NRL Report No. B-1171

Report of Test

Wind Intensity and Wind Direction Indicator System

Julian P. Friez and Sons, Inc.,  
Baltimore, Md.

Plate 1

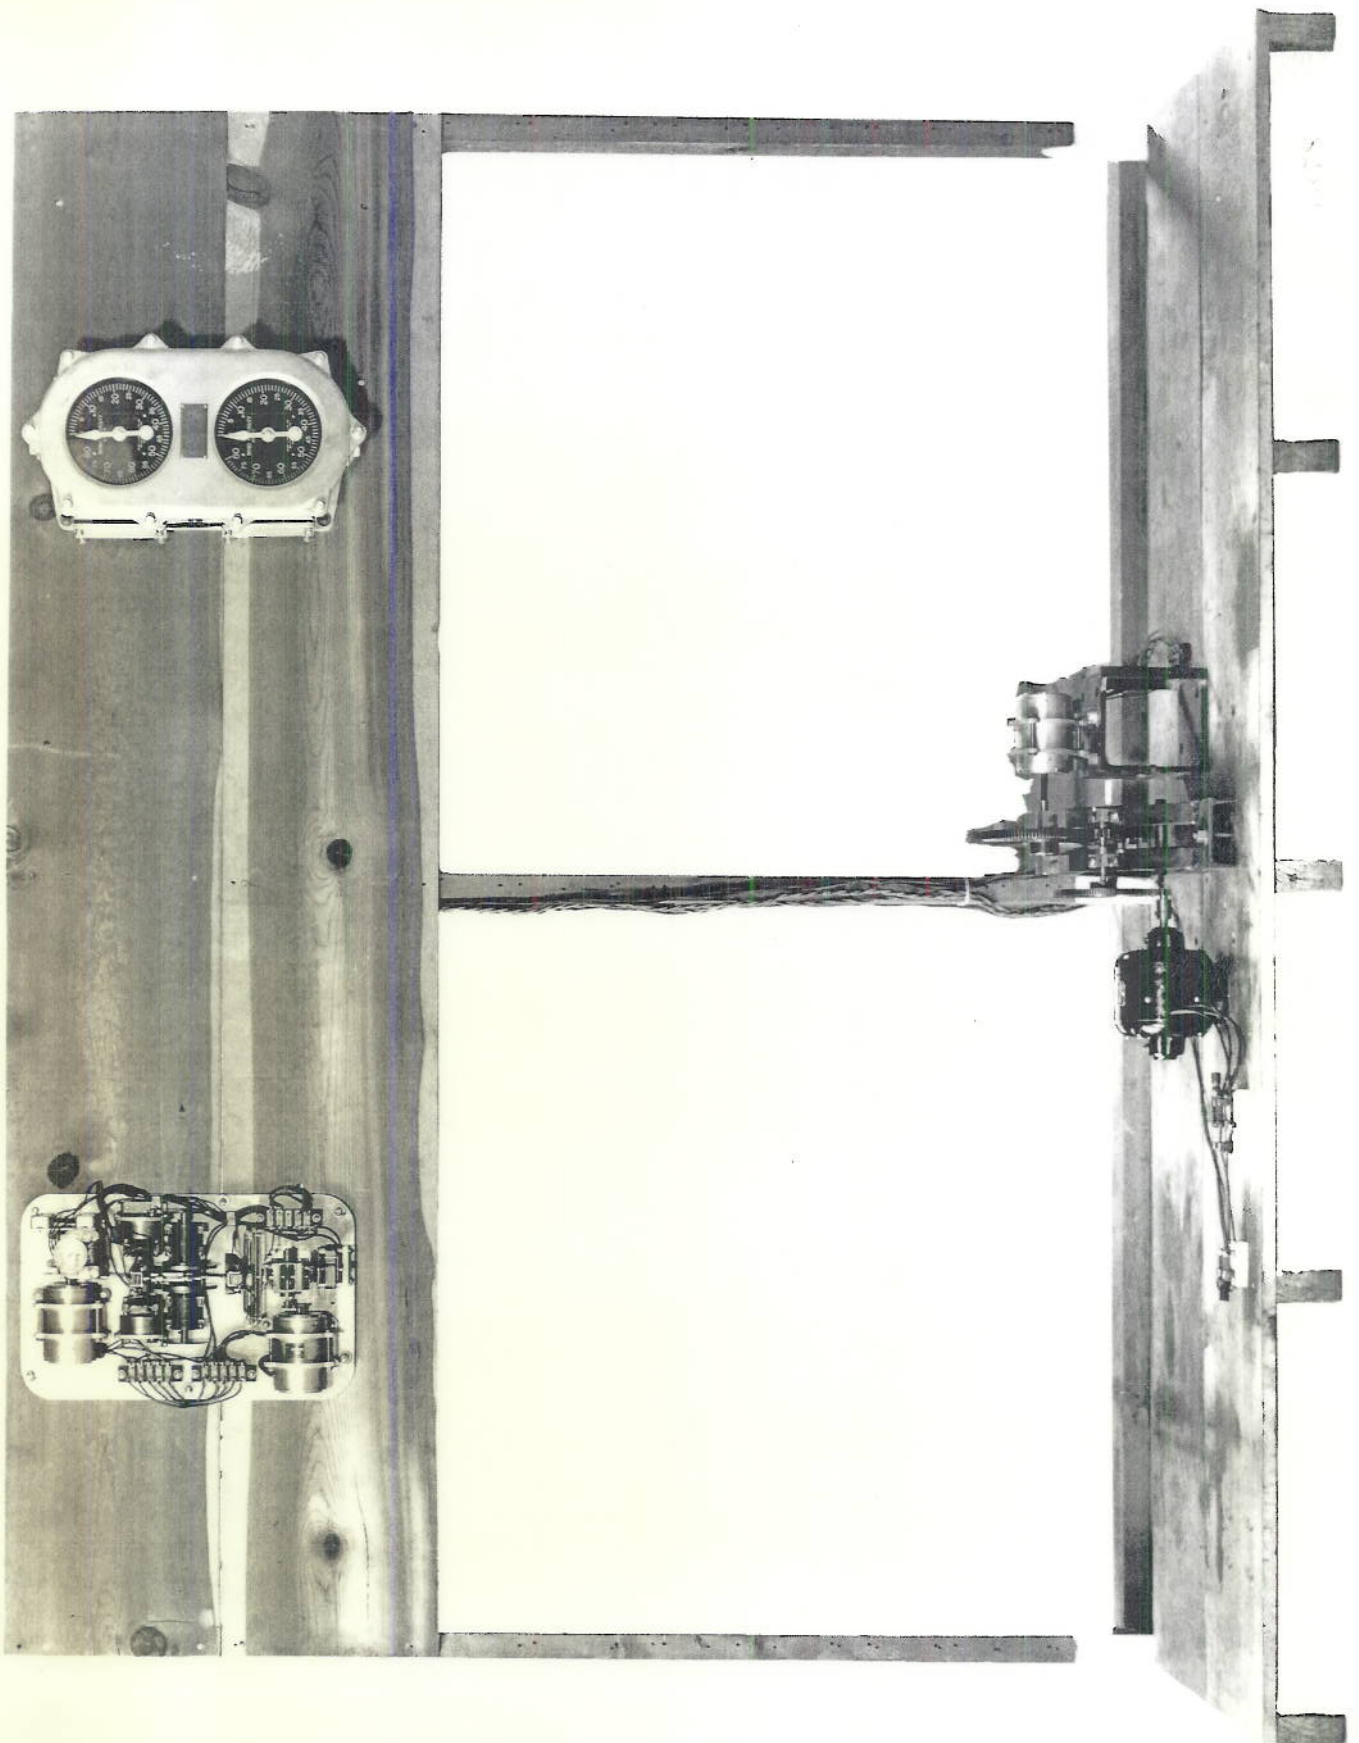
27. The system, shown by plate 1, when under test for the required 500 hour endurance run, showed an occasional error of plus or minus 2 knots. However, this was attributed to momentary variations in the frequency of the supply to the synchronous motor used for driving the Synchro-Motor transmitter. The fact that these errors occurred daily at approximately the same hour substantiates this supposition.

Plate 2

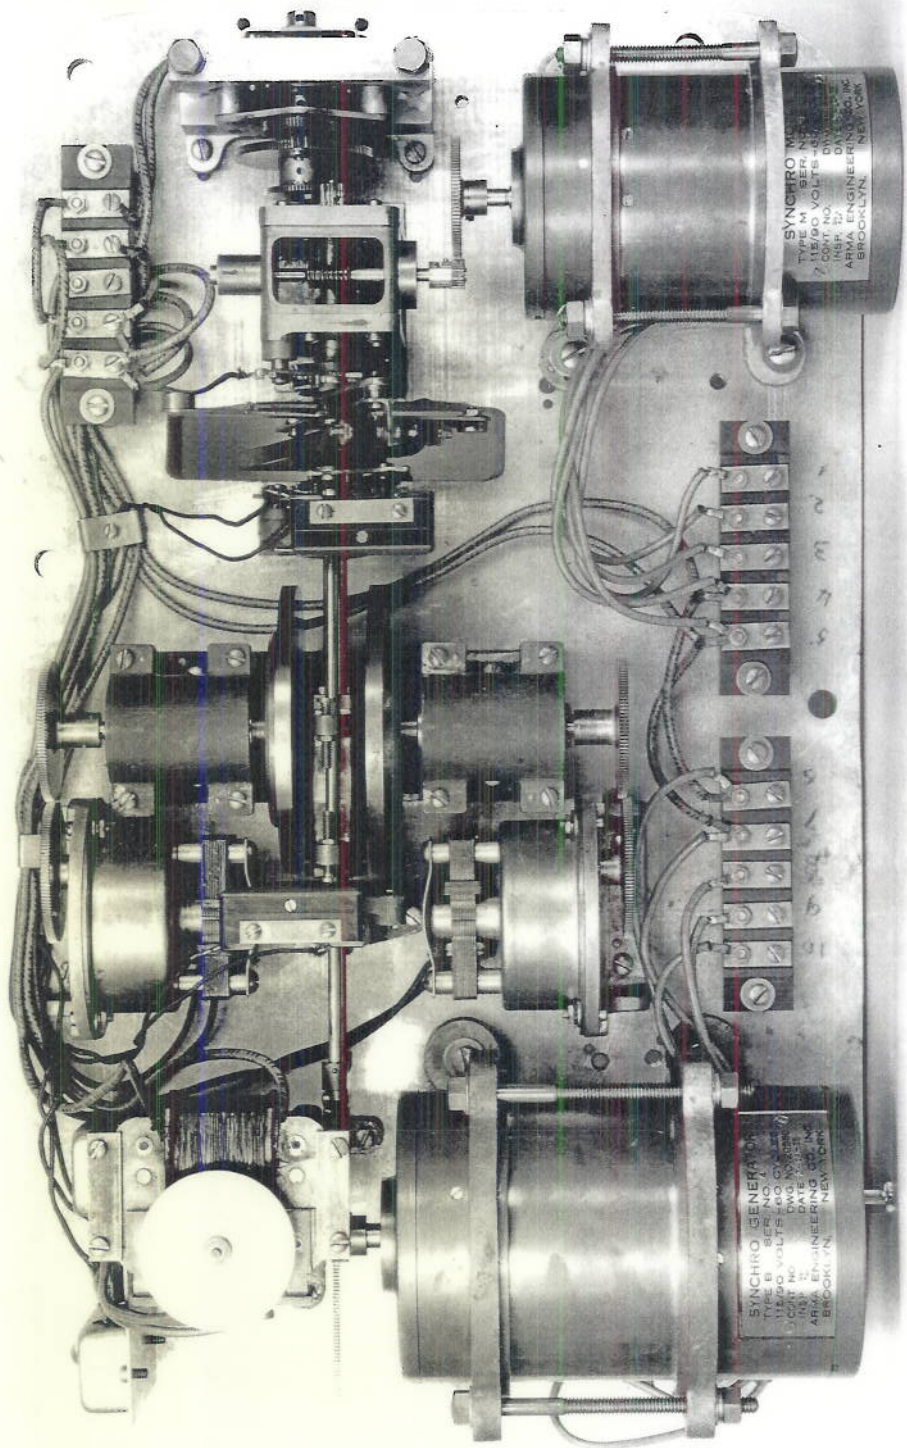
32. The Barber-Colman Shaded-Pole Induction Motor driving the oscillating contact device in the Master Transmitter did not withstand the 1500 volt dielectric test. All other parts of the subject system were satisfactory.

35. Upon examination of the material used in connection with the Master Transmitter, it was noticed that the manufacturer had consistently used brass or bronze in contact with aluminum. This is contrary to specifications.

36. When mounted in a plane  $30^{\circ}$  from vertical, top forward, the Master Transmitter introduced an additional error of approximately minus  $1/2$  knot, when operating at 65.21 knots.

37. The present diameter (3.97) of the 4 r.p.m. discs is insufficient for 80 knots. Inasmuch as the roller must move 0.0253 from the center of the discs for each knot, a radius of 2.024 is required for 80 knots. To allow for intensities exceeding 80 knots, the discs should have a diameter of at least 4.25.

38. The wiring of the Master Transmitter is unsatisfactory and the various wires used are not in accordance with the specifications.

WIND INDICATOR  
SELF-SYNCHRONOUS MOTOR TYPE  
115 VOLTS 60 CYCLE  
DRAWING NO. CV-555 1005 ALT-0  
MANUFACTURED 1934  
JULIEN P. FRIEZ & SONS, INC.  
BALTIMORE MARYLAND

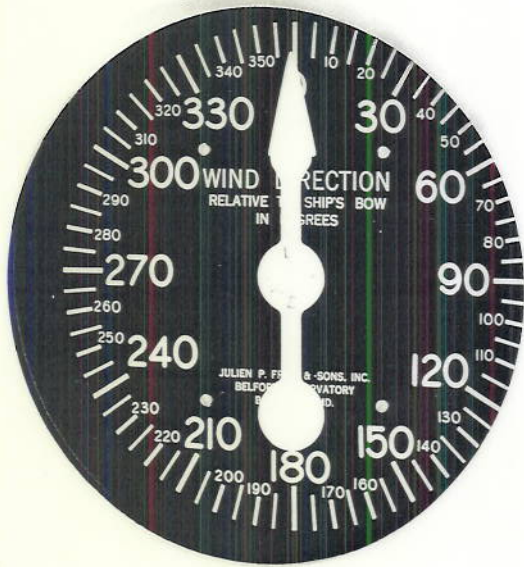
33. Under test for watertight integrity, the double Indicator case leaked 60 cc. of water. This defect was due to sand holes in the main casting. This casting has been marked at the location of the holes for the manufacturer's information.

34. The illumination in the double Indicator is not sufficient to permit its dials to be read from a distance of 6 feet in a dark room. The maximum distance from which the dials could be read was approximately 4 feet. However, few other instruments embodying the same design of lighting can be read from a distance of 6 feet.
